CONWAY WWTP

4.0 MGD EXPANSION AND UPGRADE

GSWSA PROJECT NO 8 39-01
SRF PROJECT NO 381-59

AS BUILT
5/16/03
35-009-001

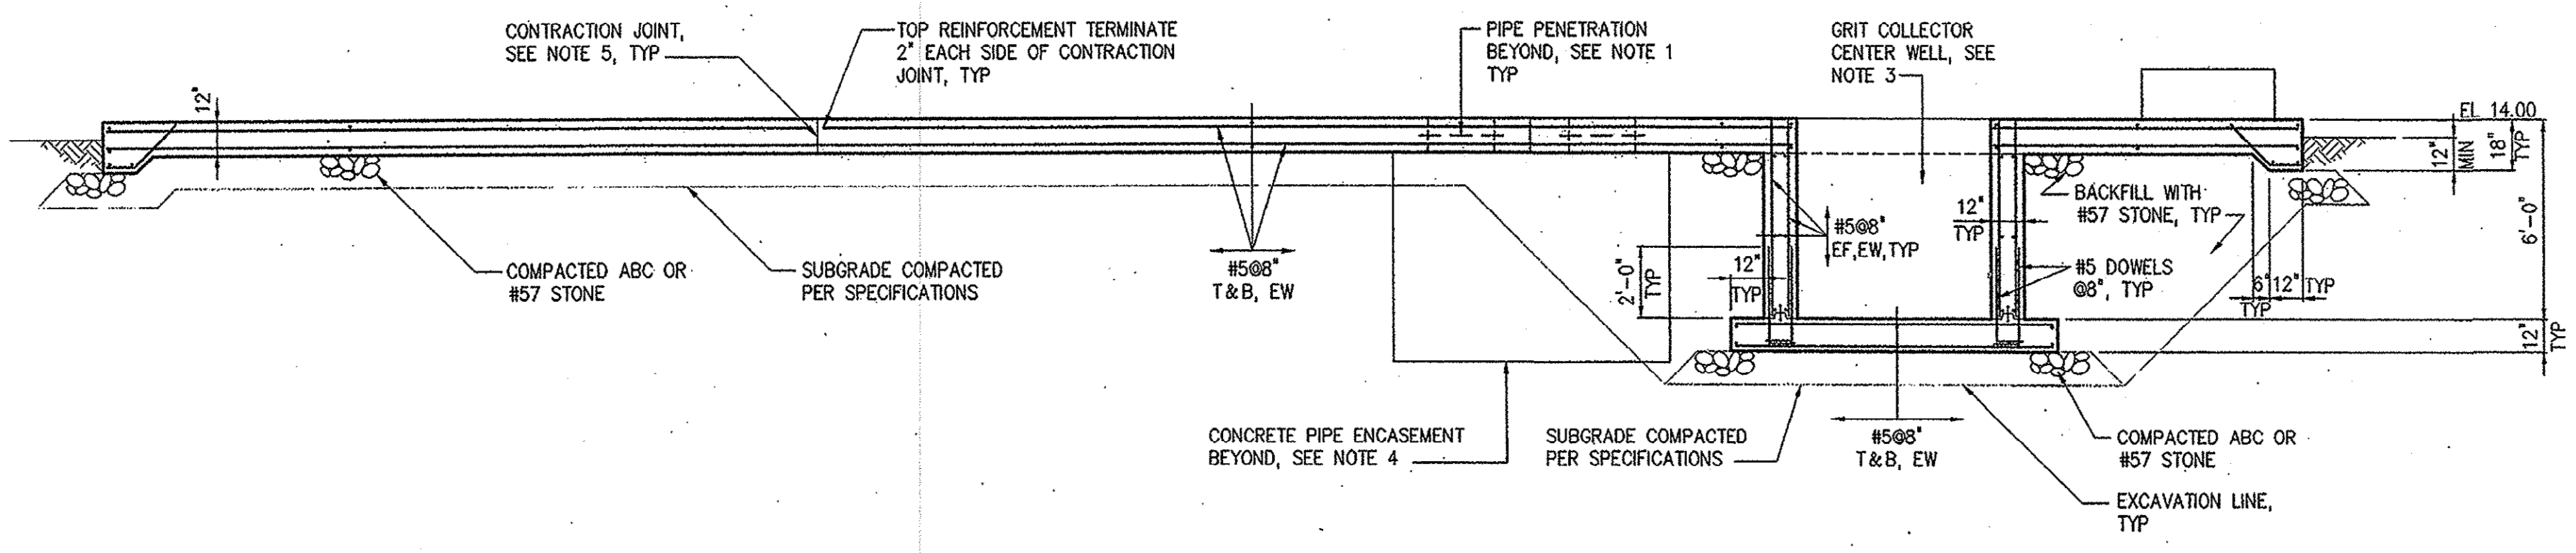
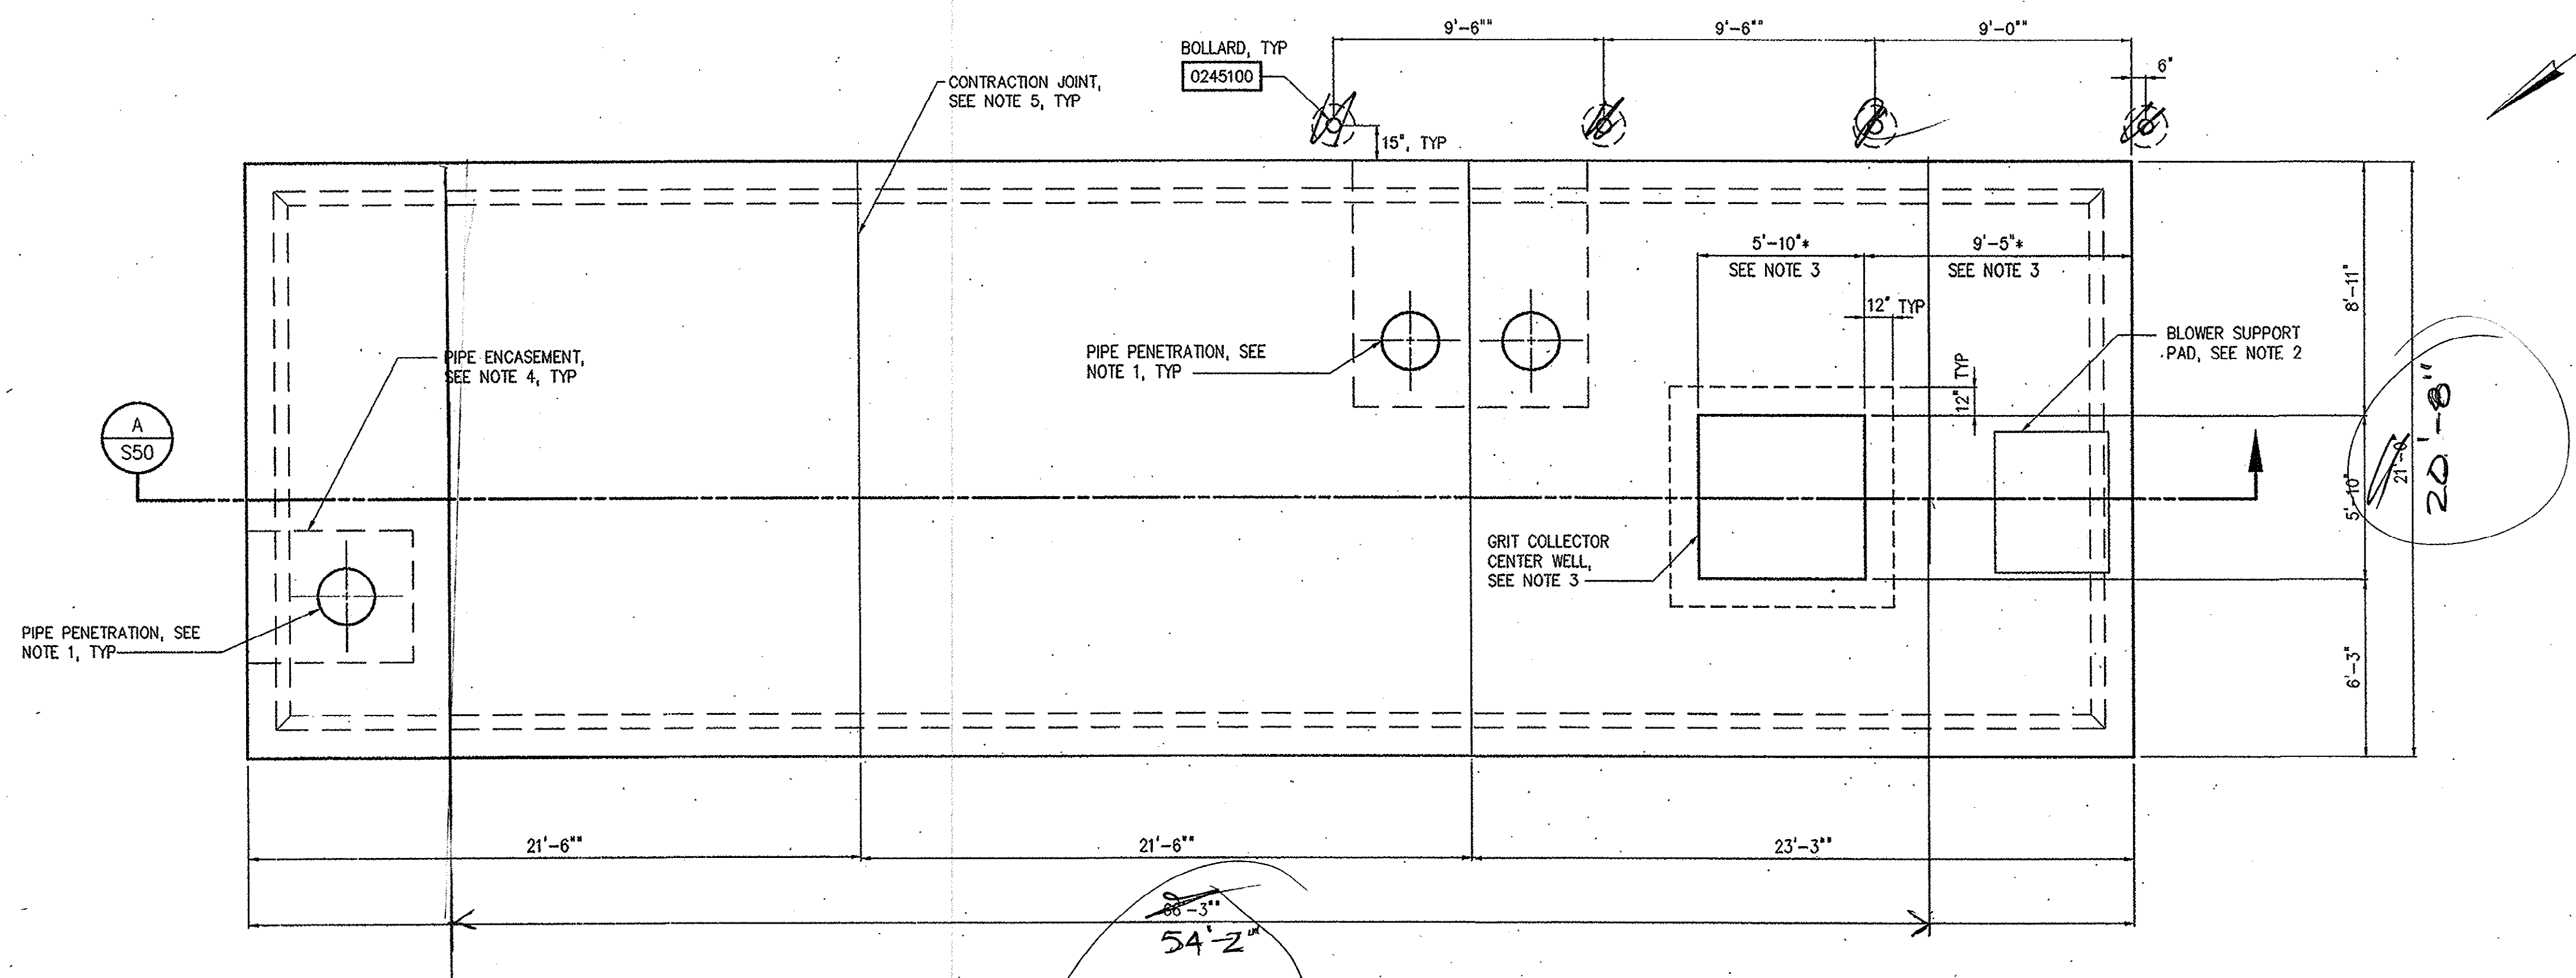
Not Installed

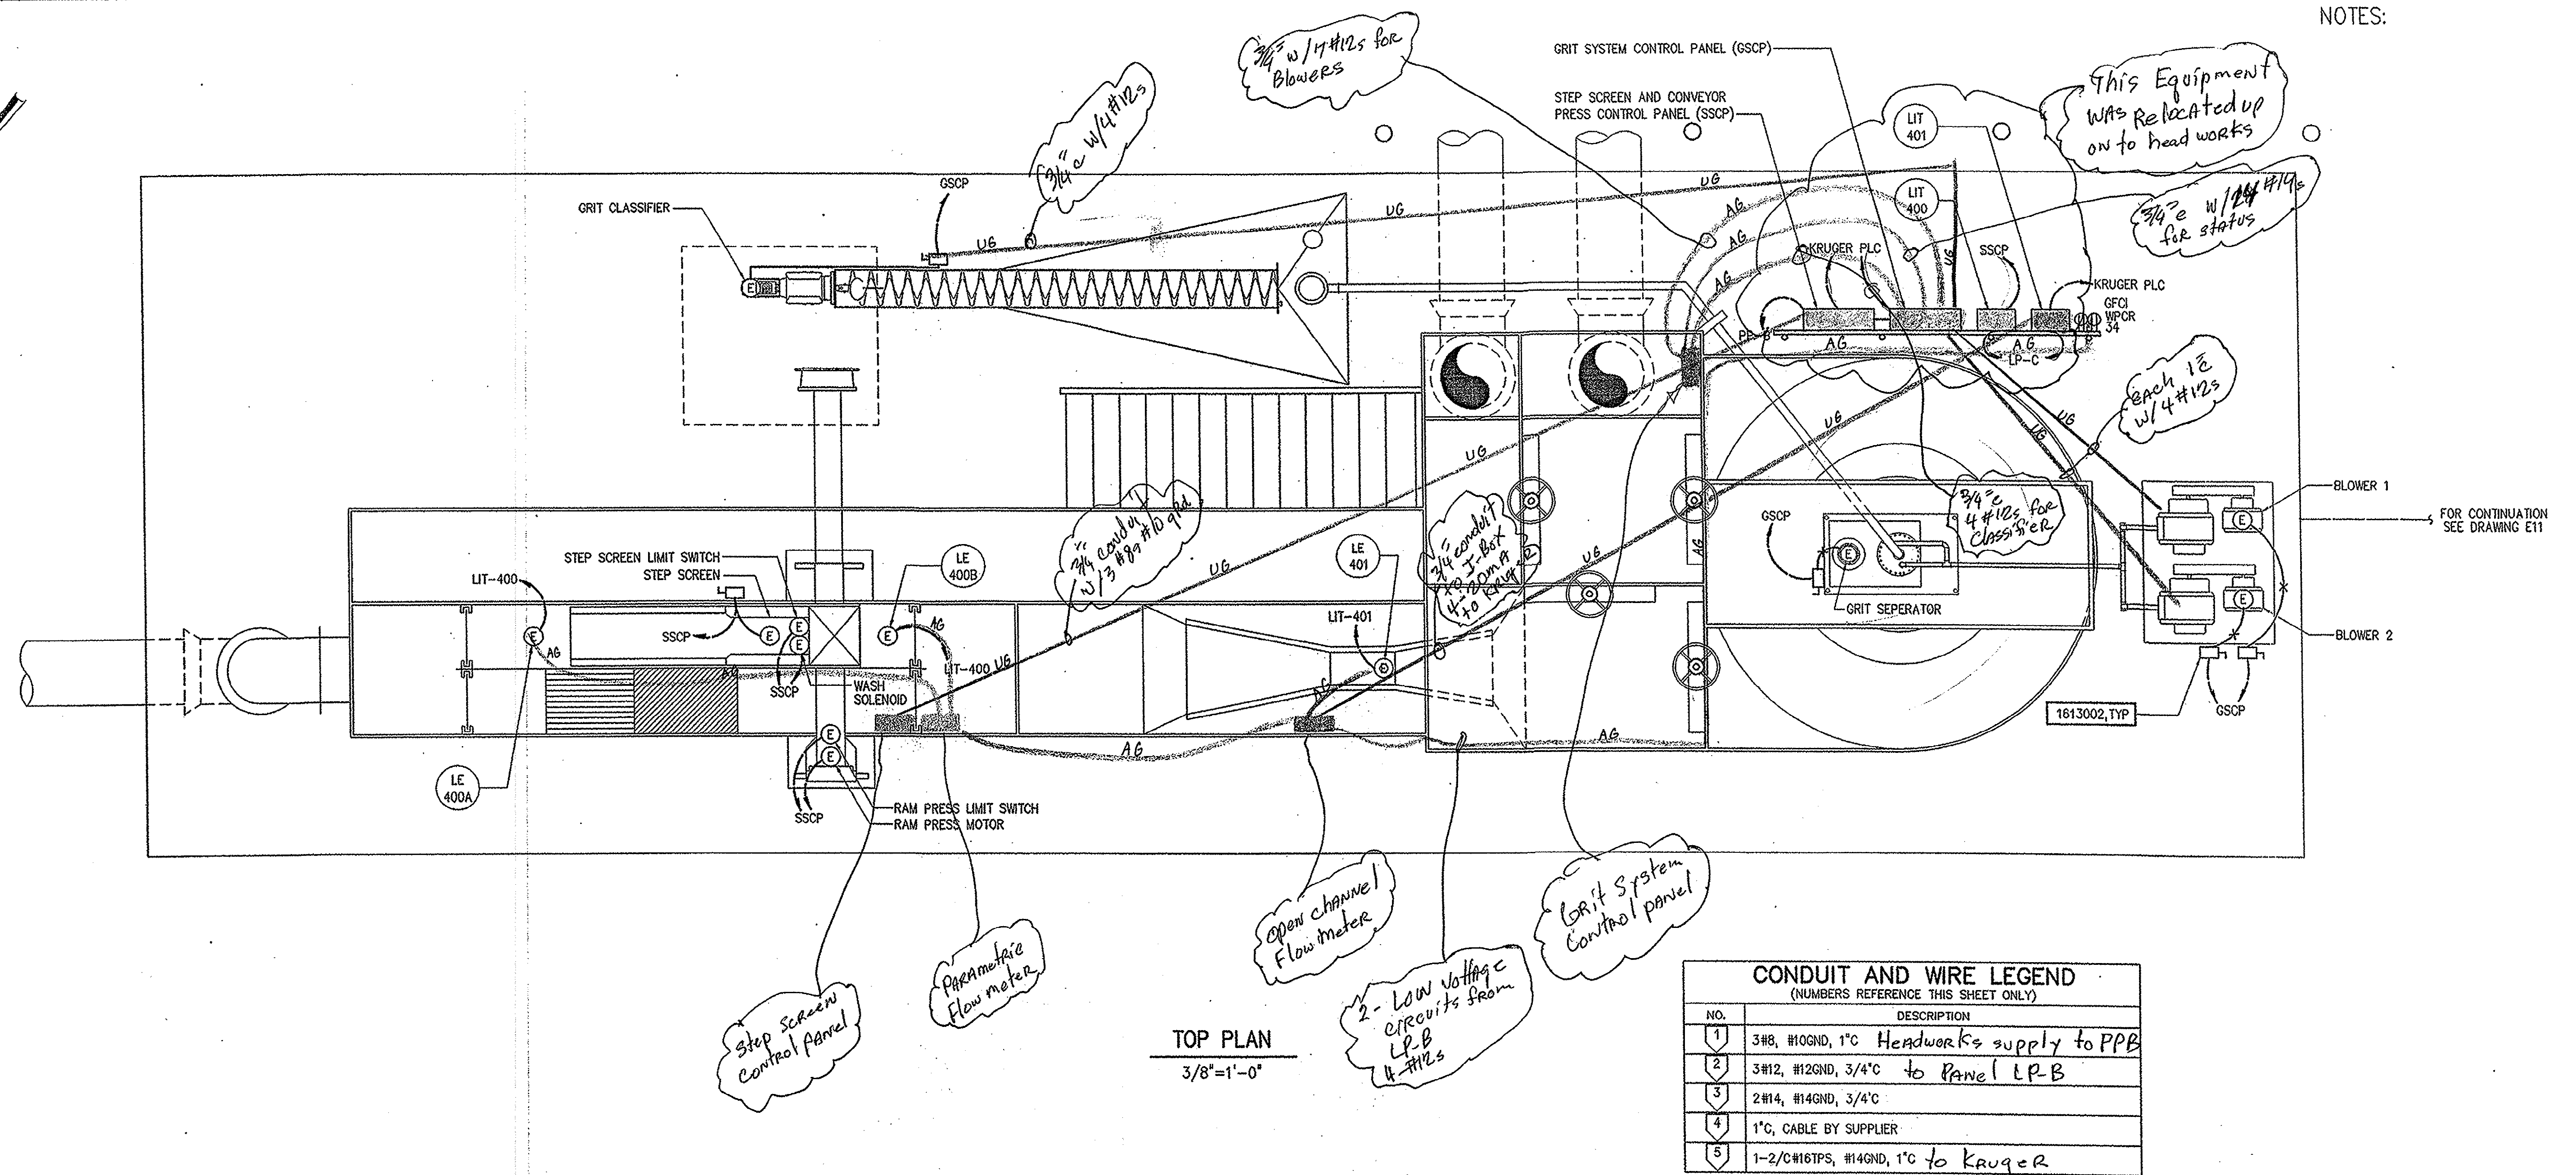
- Notes
1. Relays were added to the original installation for status indication of SSCP and GSCP.
 2. Conduit Above ground — AG
 3. Conduit below ground — UG

STEELE-PRYOR INC.
GRANDSTRAND AT CONWAY

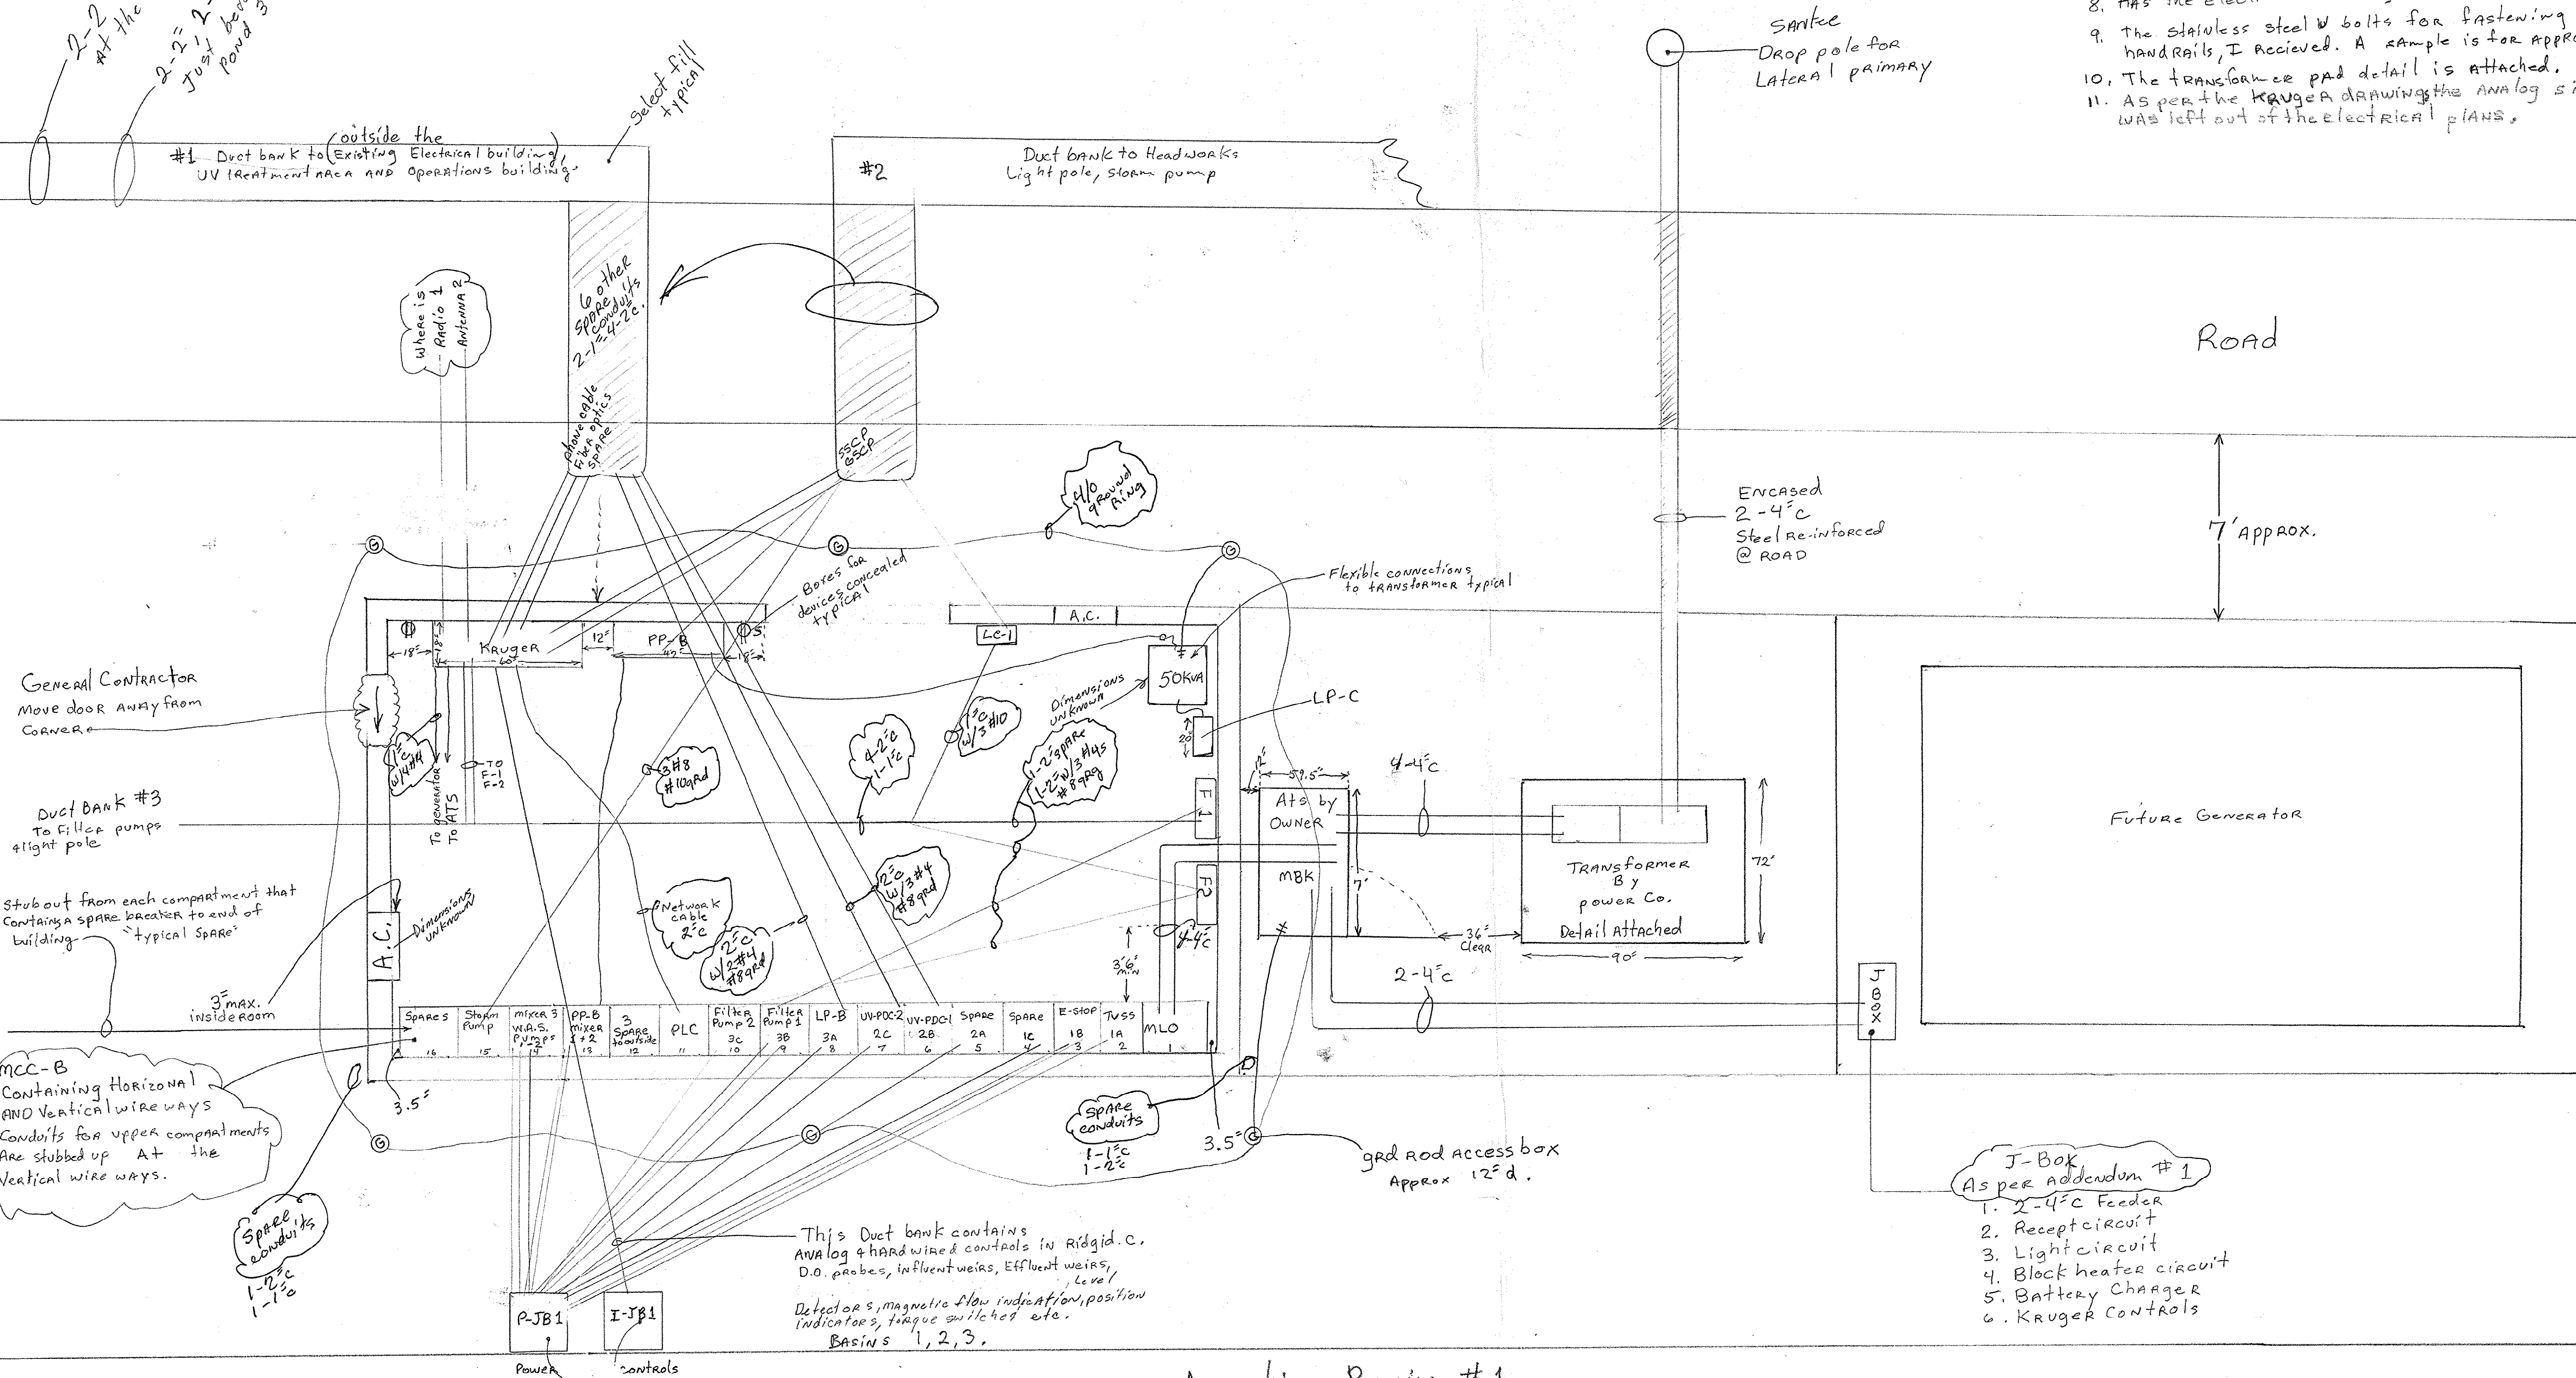
1. We need dimensions for the following items:
 - A. 50 kVA transformer.
 - B. 2 - 75 kVA transformers.
 - C. 30 amp disconnects.
 - D. 100 amp disconnects.
 - E. 2 - 200 amp disconnects.
2. Is Panel LP-B the mini power zone?
3. Where is the Existing antenna to be located? conduit to see it
4. Where is the radio located? conduit to. see E-401
5. Please select a location for the spare conduits entering the new electrical building.
6. The door near Kruger panel needs to clear the panel depth.
7. The A.C. cannot enter our clear working space.
8. Has the electrical building been moved exactly where is it?
9. The stainless steel W bolts for fastening channel to handrails, I received. A sample is for approval.
10. The transformer pad detail is attached.
11. As per the Kruger drawing the analog signal for the blowers 1 was left out of the electrical plans.
